Manual Supplement

Manual Title:	7526A Getting Started	Supplement Issue:	2
Part Number:	4218030	Issue Date:	8/12
Print Date:	July 2012	Page Count:	1
Revision/Date:

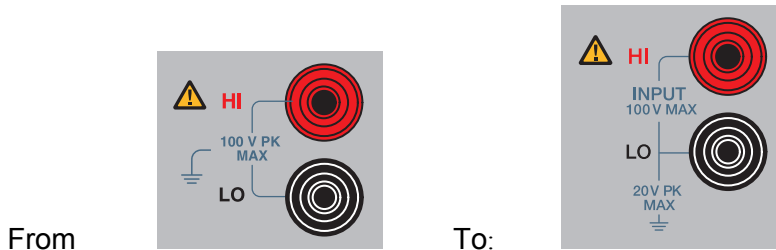
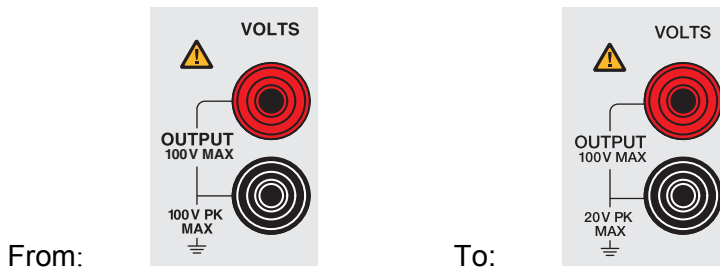
Change #2

Throughout the manual, change all **Front Panel** figures:
